ENGINEERING BULLETIN
COALTRAM®
Procedural Changes to Installation of Turbo

Ref Document No.	EB13001	Issue No.	1
Release Date

To advise machine owners of a possible sealing issue at exhaust manifold to turbo joint interface which could affect the integrity of the flame proof joint.

EXHAUST
MANIFOLD
TO TURBO
JOINT

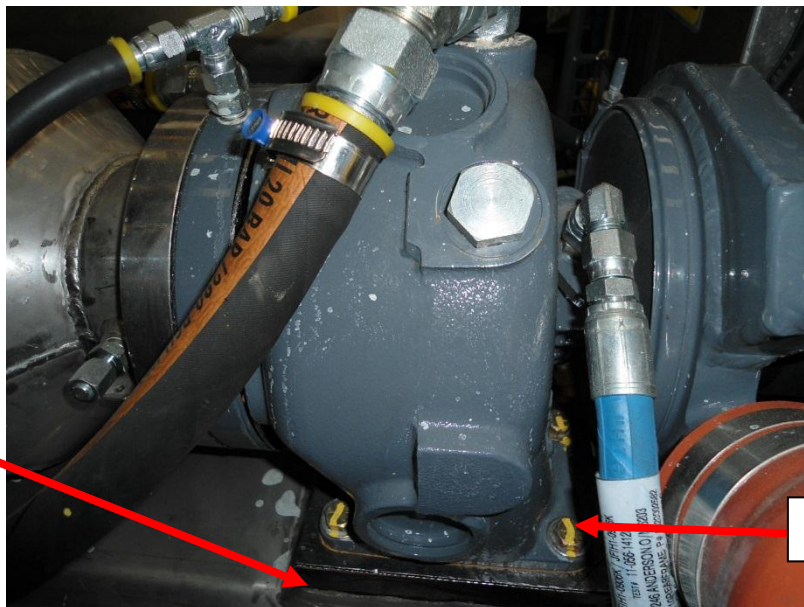
Further investigation revealed a gas leak at exhaust manifold to turbo joint interface due to a fastener being loose securing the turbo to exhaust manifold.

FASTENER

Check bolt torque and adjust to correct specification if needed. Proceed with steps below.

Install bolts without applying a locking agent and torque to correct specification. Proceed with steps below.

1. Start engine and let run until engine reaches normal operating temperature.
2. Stop engine and allow system to cool to ambient temperature.
3. Individually remove each turbo to exhaust manifold mounting bolt, one at a time, apply Loctite 243 and tighten bolts to specified torque.
4. Test for gas tightness by way of soapy water test.
5. For further information refer to Safe Work Procedure SWP CT3.17
